**STATE OF HAWAII
DEPARTMENT OF TRANSPORTATION
HIGHWAYS**

**ADDENDUM NO. 2
FOR
TRAFFIC SIGNAL MODERNIZATION, OAHU, PHASE 2A
DISTRICT OF HONOLULU
ISLAND OF OAHU
FEDERAL-AID PROJECT NO. STP-0300(214)**

NOVEMBER 8, 2024

FED. ROAD DIST. NO.	STATE	PROJ. NO.	FISCAL YEAR	SHEET NO.	TOTAL SHEETS
HAWAII	HAWAII	STP-0300(214)	2024	ADD.102	149

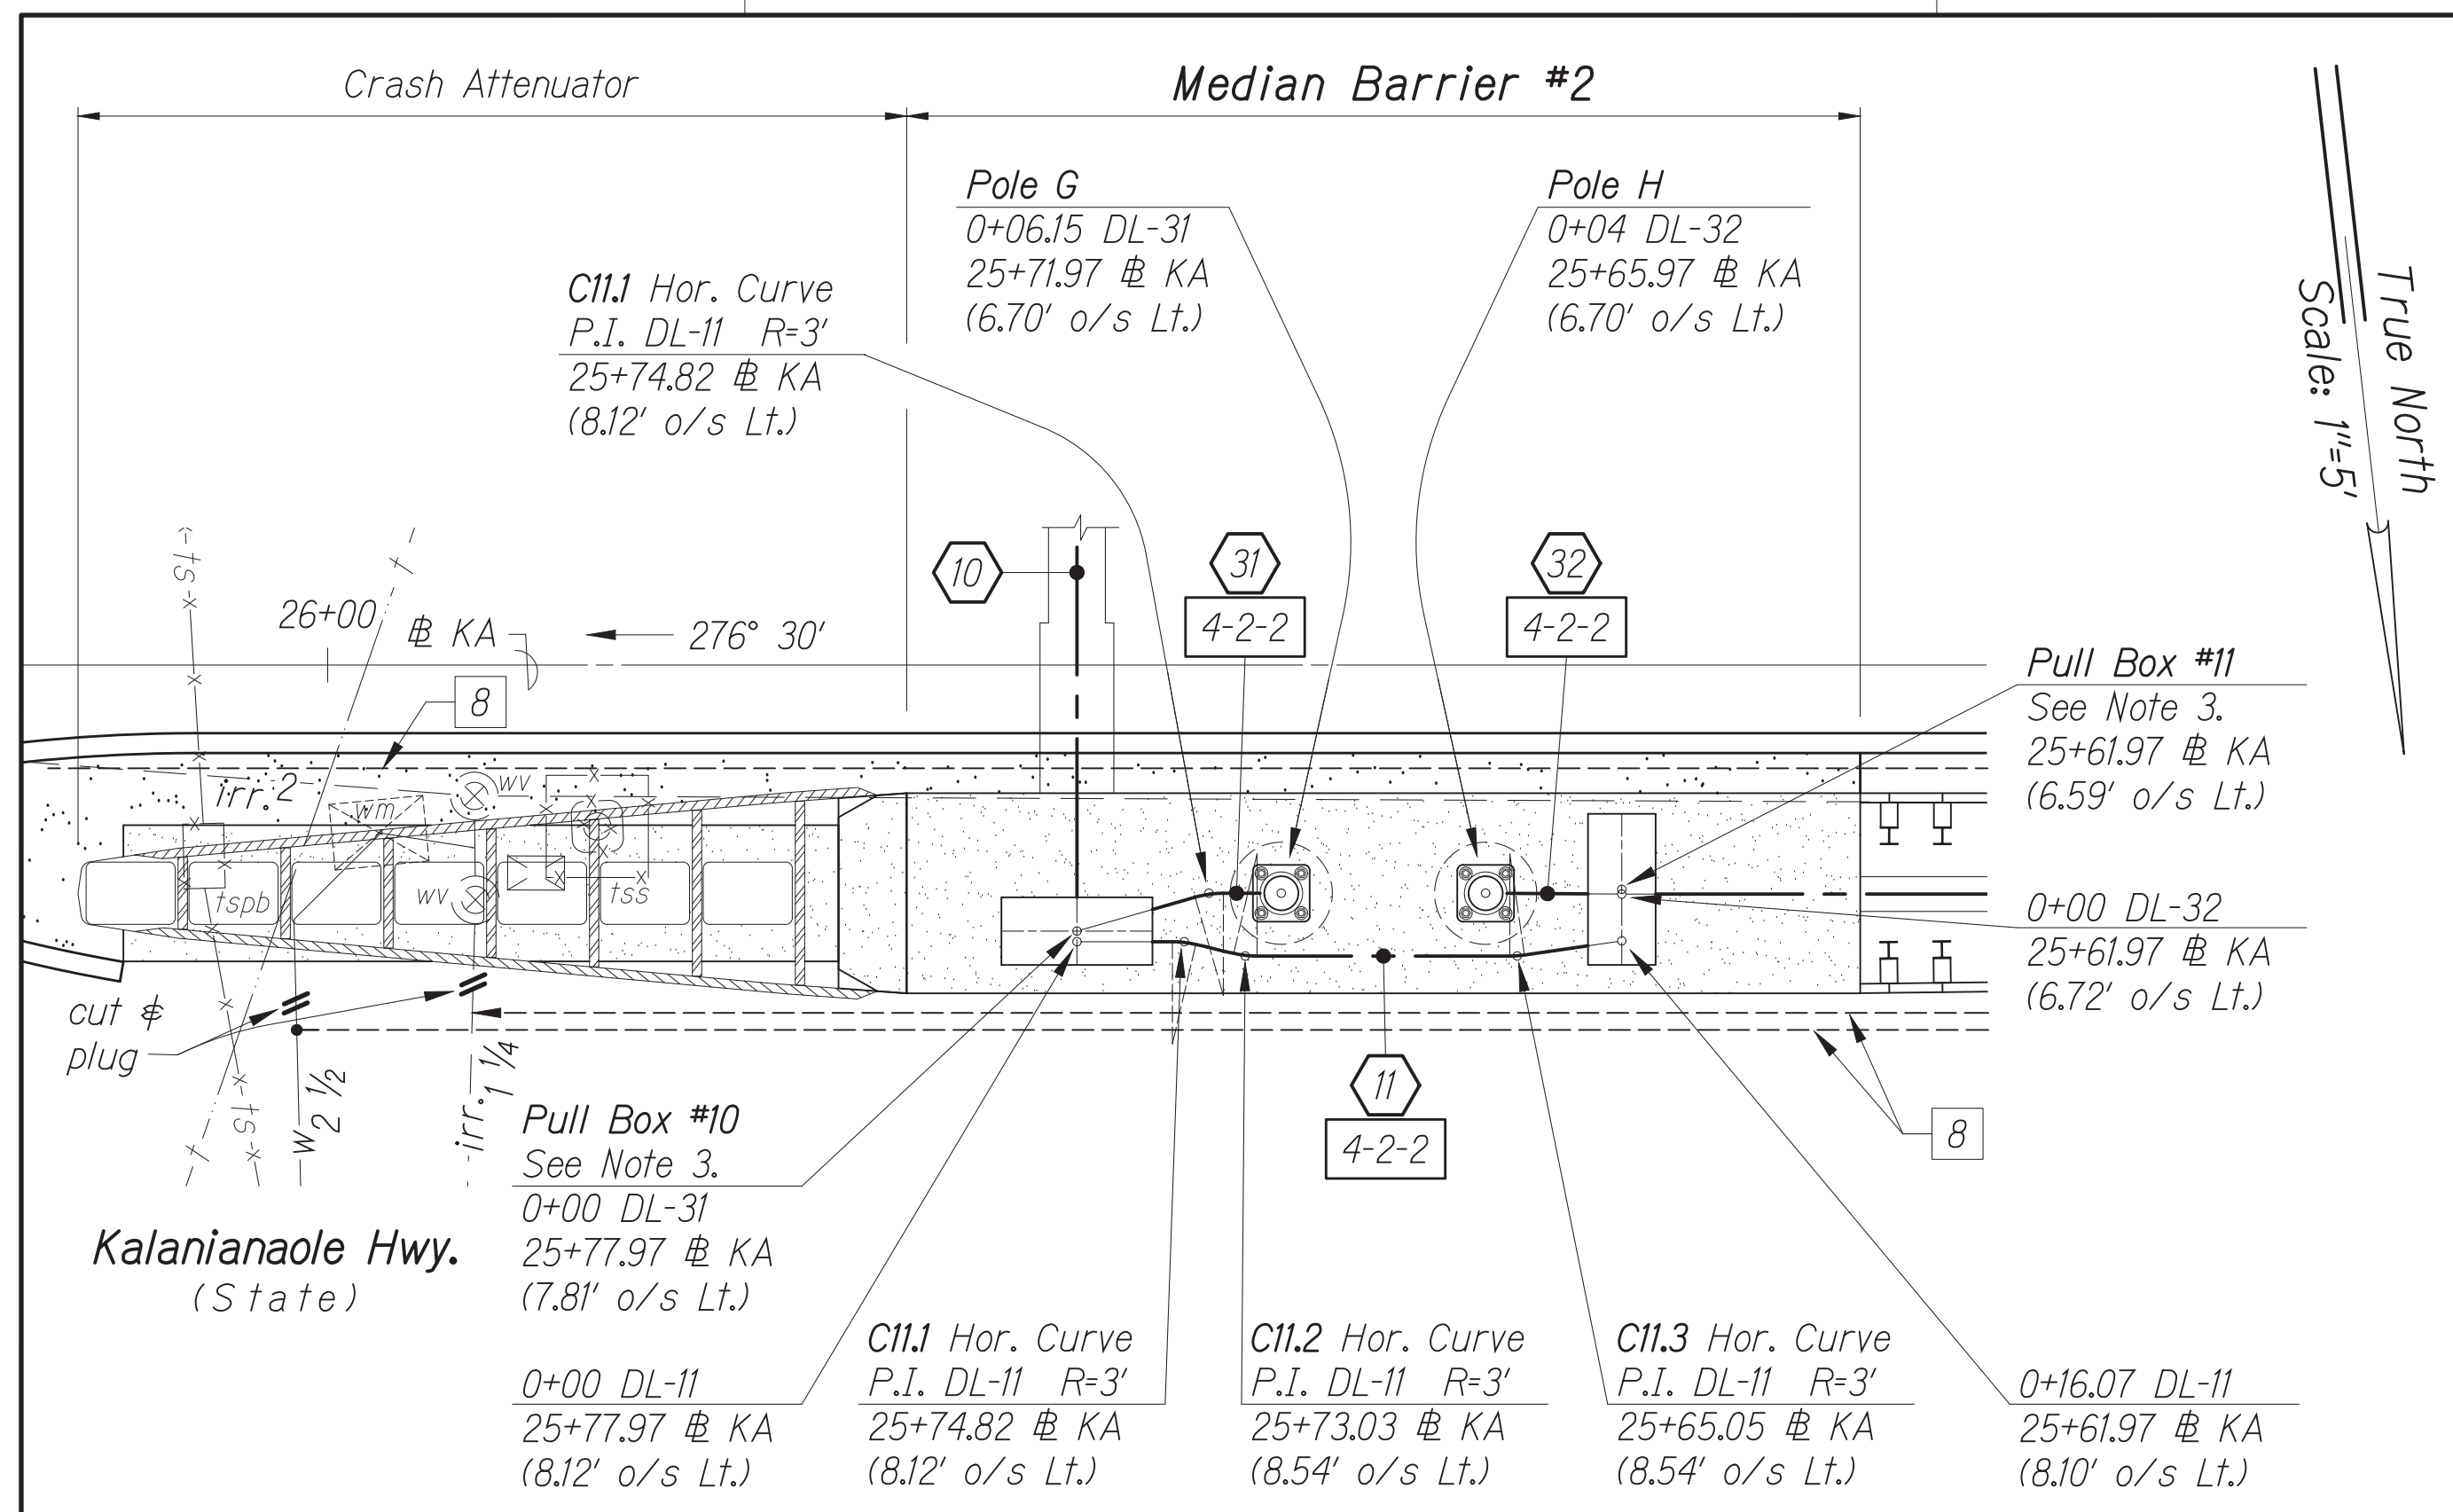
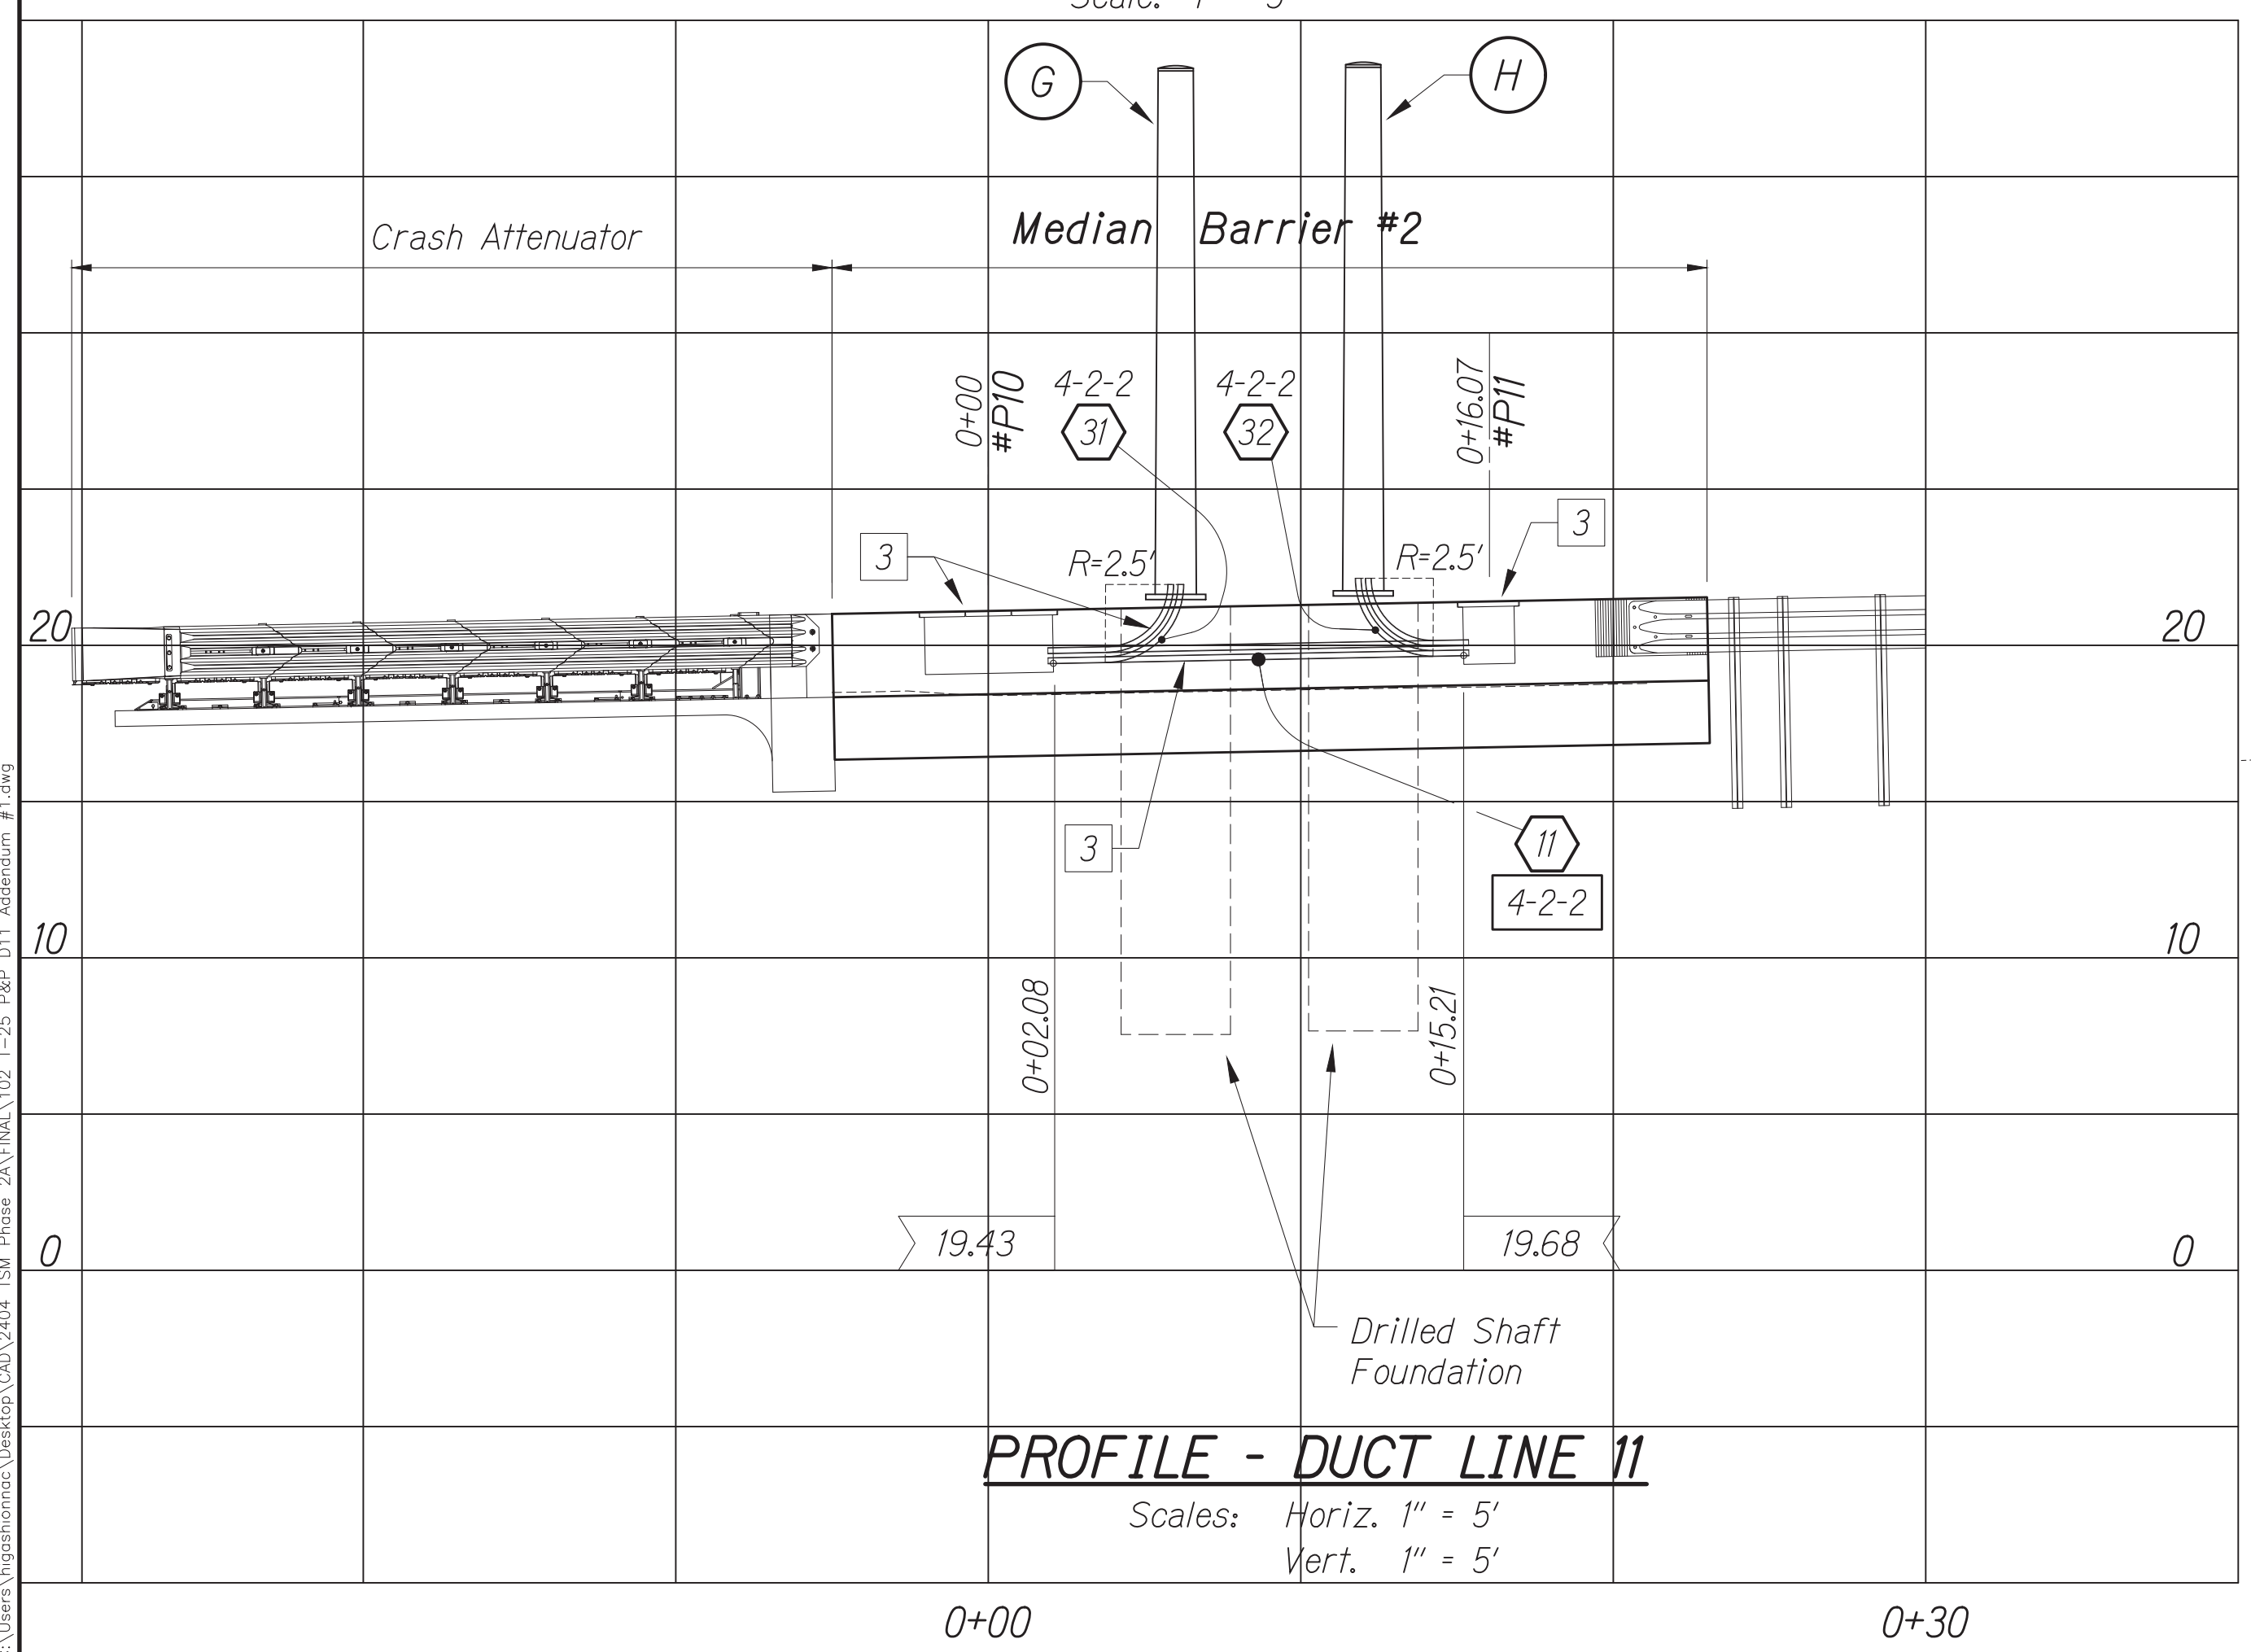
REVISION	DATE
Revised call out to 17-foot minimum clearance (in lieu of 15-foot) from bottom of street name sign on mast arm to top of pavement of travel lane.	11/8/24
